Access Compliance Report

Public Rights-of-Way (Curb Ramps)

Intersection ID: 3704	Main Street: HARRIS_CORNERS_PY	Cross Street: HARRIS_OAKS_BV	Location:	E
ADA ID: 779FEEBDBA39	Ramp Type: Perp	Initial Pass/Fail: Fail	Overall Compliance: No	Severity Score: 22.5

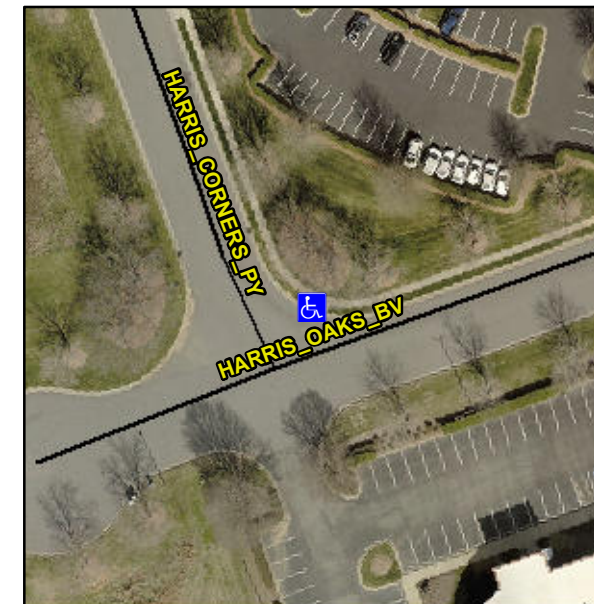
Not Found, R304.5.1, R304.2.2, R304.5.3

Compliance	Description	Data	Compliance	Description	Data
N/A	Ramp Length (in)	47.0	No	Ramp Slope (%)	11.0
No	Ramp Width (in)	43.0	No	Ramp XSlope (%)	3.9
N/A	Flare Type LT	N/A	N/A	Flare Type RT	N/A
N/A	Flare Slope LT (%)	N/A	N/A	Flare Slope RT (%)	N/A
N/A	Flare Traversable LT?	N/A	N/A	Flare Traversable RT?	N/A
N/A	Landing Length (in)	N/A	N/A	DWS Provided?	N/A
N/A	Landing Width (in)	N/A	N/A	DWS Contrast?	N/A
N/A	Landing Slope (%)	N/A	N/A	DWS Length (in)	N/A
N/A	Landing X Slope (%)	N/A	N/A	DWS Full Width?	N/A
N/A	Landing Curb? (Y/N)	N/A	N/A	DWS Offset (in)	N/A
N/A	Shared Landing?	N/A			
N/A	Gutter Ponding?	N/A	N/A	Gutter Slope (%)	N/A
N/A	Gutter Lip Ht (in)	1.0	N/A	Gutter X Slope (%)	N/A
N/A	Painted X Walk1?	No	N/A	Painted X Walk2?	N/A
	X Walk 1 Direction	To W		X Walk 2 Direction	N/A
N/A	X Walk 1 Width (in)	N/A	N/A	X Walk 2 Width (in)	N/A
	X Walk 1 Slope (%)	1.0		X Walk 2 Slope (%)	N/A
	X Walk 1 X Slope (%)	1.4		X Walk 2 X Slope (%)	N/A

Remove & Replace Entire Ramp.
